CITY OF SACRAMENTO PLANNING COMMISSION
1231 "I" STREET, SUITE 200, SACRAMENTO, CA 95814

PROPOSAL: The applicant is requesting the necessary entitlements to expand the Kaiser South Sacramento Medical Center with a 7,335 square foot out-patient surgical center and a 47,938 square foot addition to the surgery area.

C.NO. P90-301

MEETING DATE July 25, 1991

EXHIBIT - A SITE PLAN

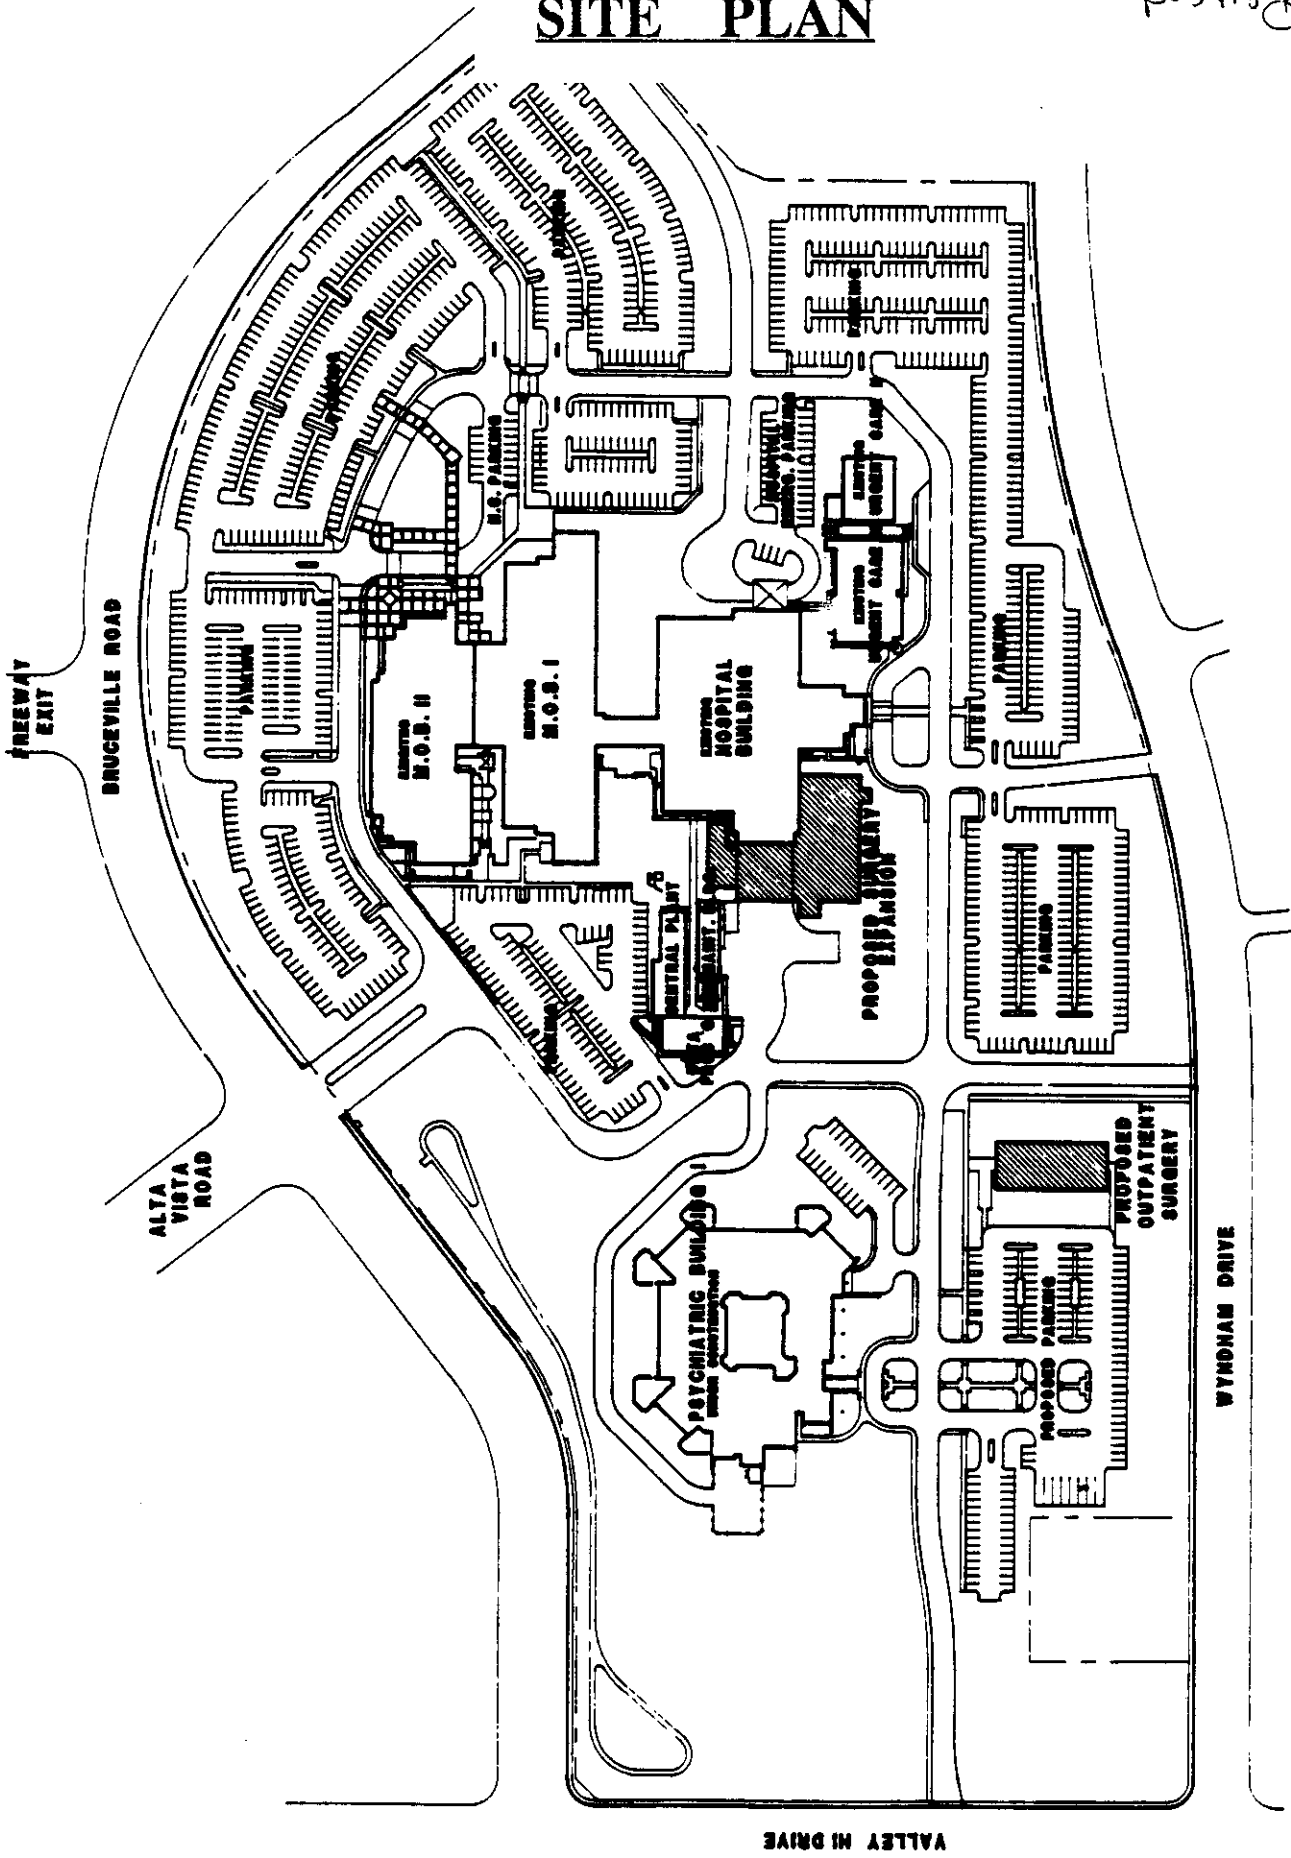
The site plan (Exhibit A) indicates the existing facilities and the proposed construction under this application on the subject site. The 47,938 square foot surgery expansion contains three stories and is attached to the main hospital building. The proposed 7,335 square foot outpatient surgery center is a single story, free-standing building facing Wyndham Drive. The site currently contains the 176 bed hospital, two medical office buildings totaling 153,900 square feet, a central plant and maintenance containing 11,900 square feet, two urgent care facilities totaling 15,000 square feet, and a 48 bed psychiatric hospital. At buildout, the site is proposed to have two additional medical office buildings and additions to both the psychiatric hospital beds and the hospital beds. Each addition will require a new special permit to be reviewed by the Planning Commission.

The existing facilities on the site and the proposed surgery expansion and outpatient surgery expansion require a total of 1,407 parking spaces. The submitted site plan indicates 1,408 spaces provided. There is adequate parking available on the site, however, as the other uses are developed, additional parking will be required. The site plan indicates the additional parking to be provided for the outpatient surgery center to the west of the building. Staff has no objection to this location. The proposed parking should meet the size and

maneuvering requirements of the Zoning Ordinance, as well provide 50 percent shading. A detailed landscape plan should be submitted for review and approval of the Planning Director indicating the landscaping within the parking lot as well as the landscaping to be provided between the proposed outpatient surgery center and Wyndham Drive.

- 2. The proposed parking shall meet the size and maneuvering requirements of the Zoning Ordinance and well provide 50 percent shading. A detailed landscape plan shall be submitted for review and approval of the Planning Director indicating the landscaping within the parking lot as well as the landscaping to be provided between the proposed outpatient surgery center and Wyndham Drive. As the other uses are developed on the site, additional parking will be required.

EXHIBIT - G

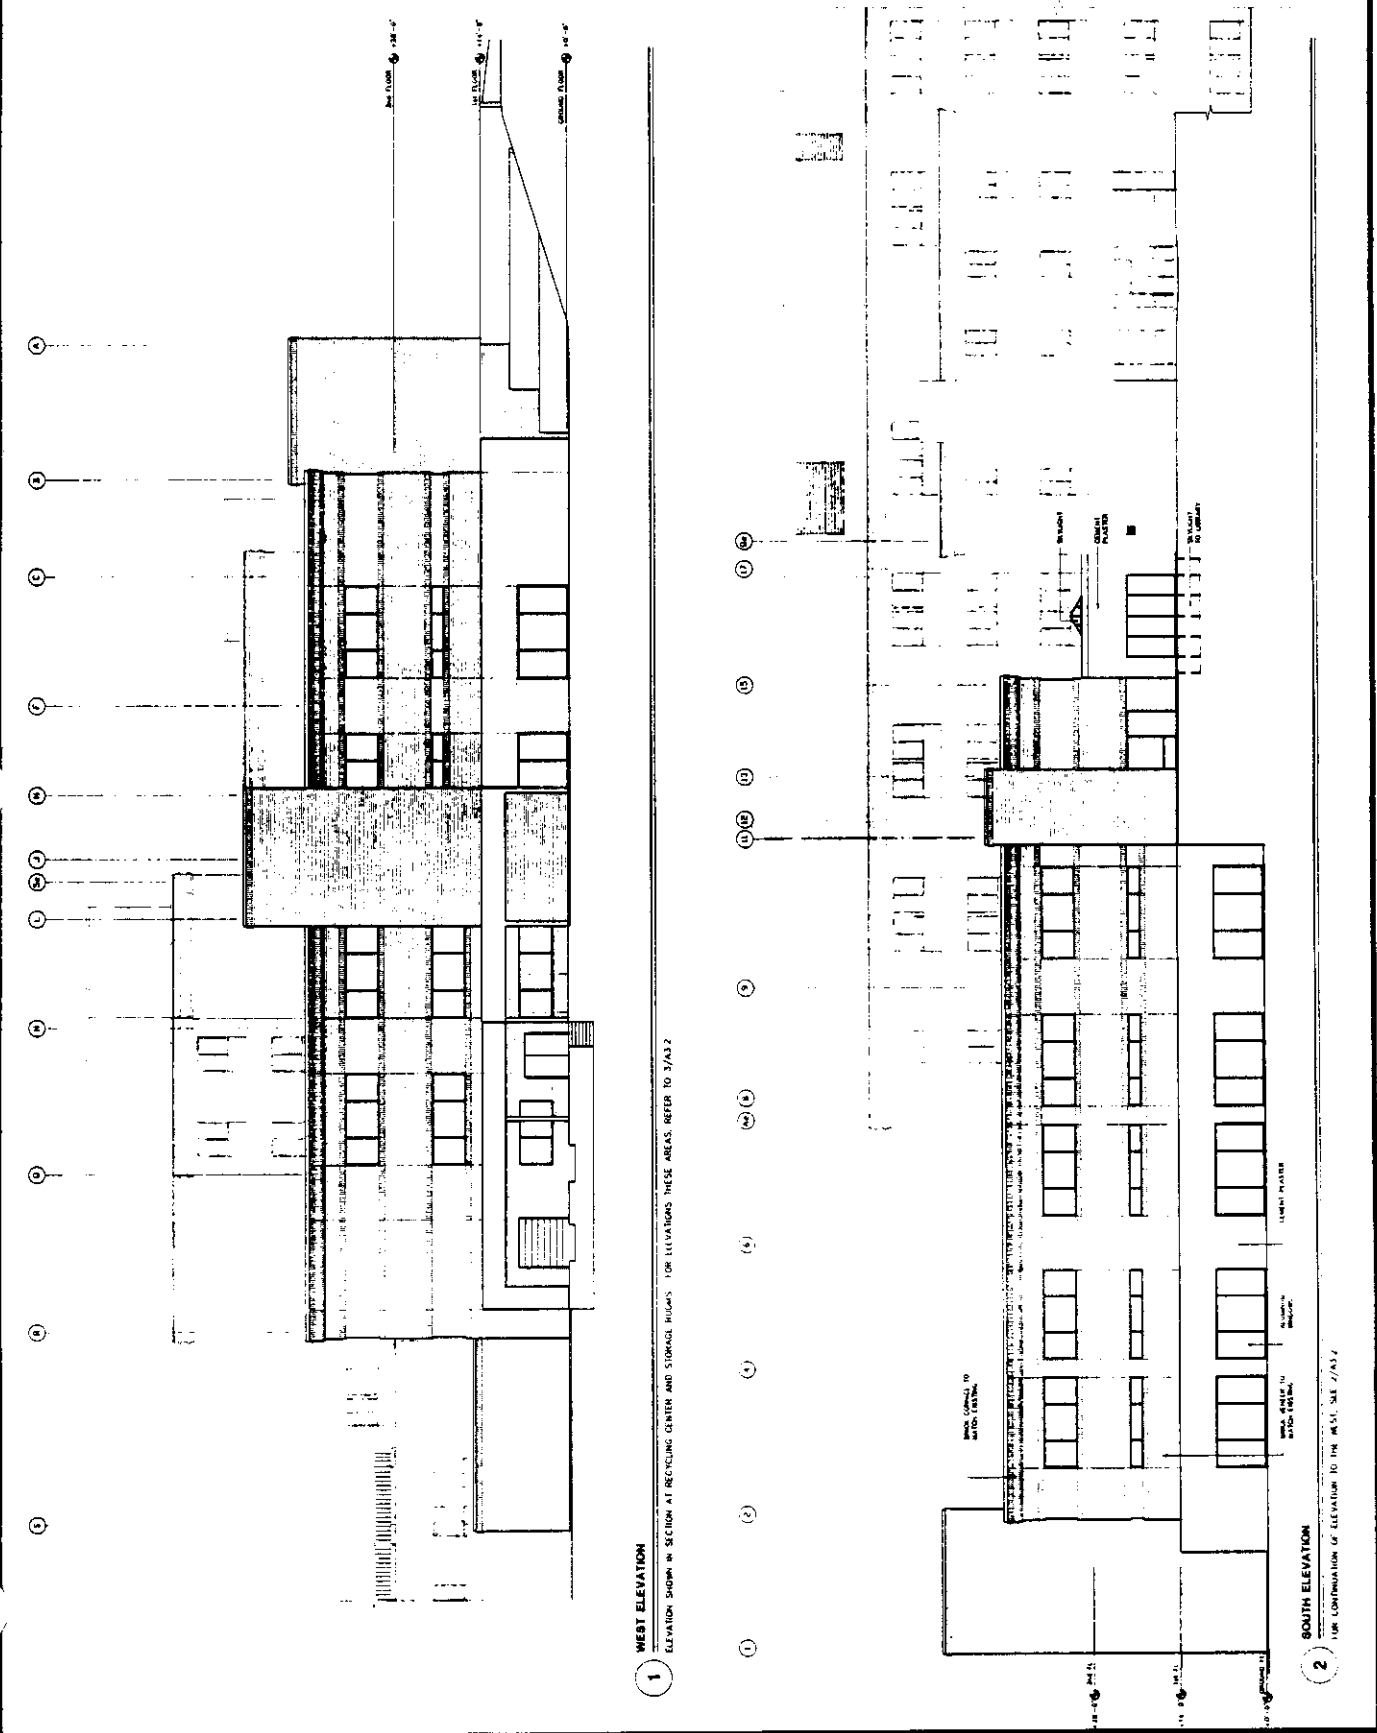
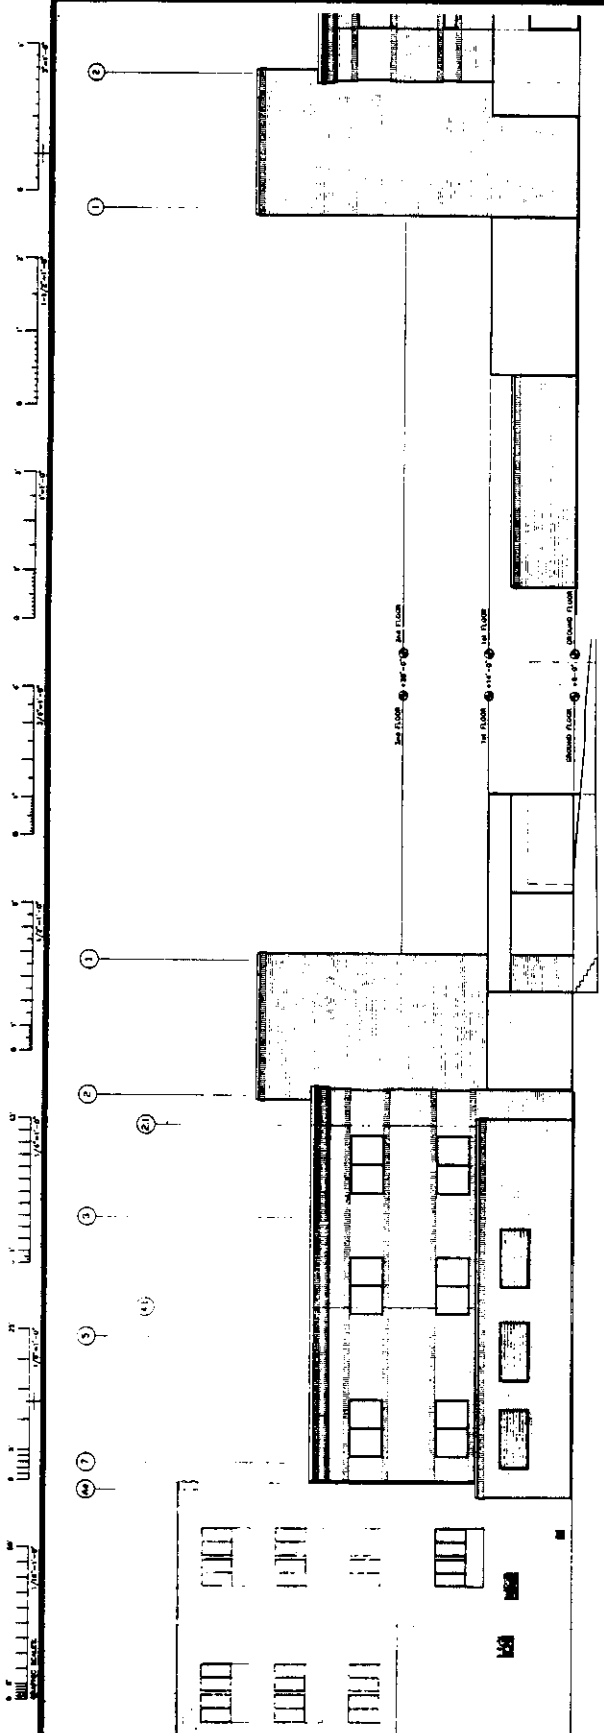
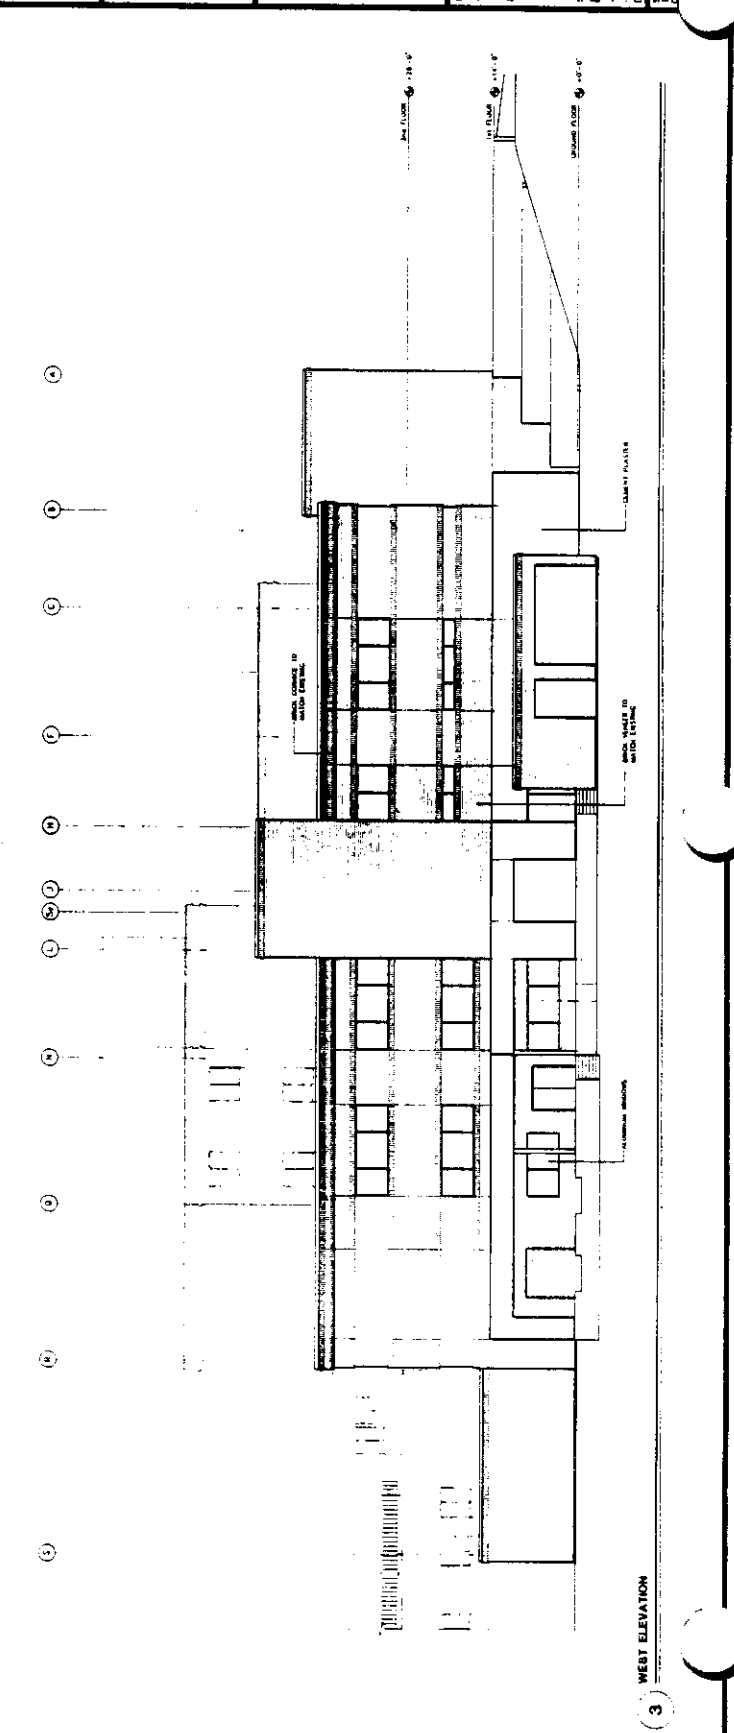
The proposed hospital surgery expansion design (Exhibits F and G) contains three stories with brick and cement plaster exterior. The roof is built-up asphalt. Staff has no objection to the design of the addition. It is designed to be compatible with the exterior of the existing hospital.

- 3. The hospital surgery expansion shall be developed as per the submitted elevations.
- 4. Revised elevations for the outpatient surgery center shall be submitted for review and approval of the Planning Director prior to the issuance of Building Permits. These revised elevations shall include a south elevation enhanced with standing seam metal canopies. A color sample shall also be submitted for the standing seam metal roof.

EXHIBIT - H

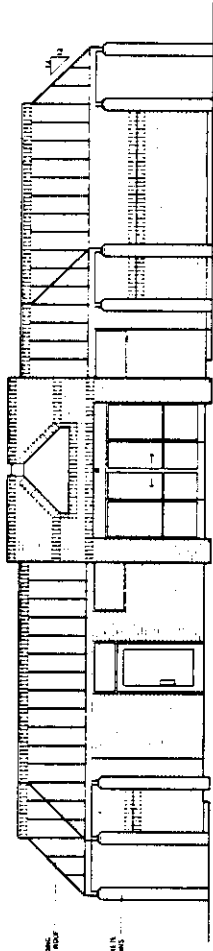
The proposed outpatient surgery center (Exhibit H) also contains exterior materials of brick and cement plaster. The roof material consists of a combination of built-up asphaltic materials and standing seam metal. The standing seam metal roof shall be of a color similar to the one existing on the hospital. A color sample should be submitted for review and approval of the Planning Director prior to the issuance of Building Permits. The north elevation is the main entrance to the building. The entrance has been high-lighted with brick accents and the standing seam metal roof. The metal roof is also used to cover entrances and walkways on the east and west elevations. The south elevation, however, contains no metal roof canopies. Staff is concerned with the south elevation since it faces Wyndham Drive. Staff suggests the metal roof canopies cover the doorways on this elevation as on the others. Revised elevations indicating the enhanced south elevation should be submitted for review and approval of the Planning Director prior to the issuance of Building Permits.
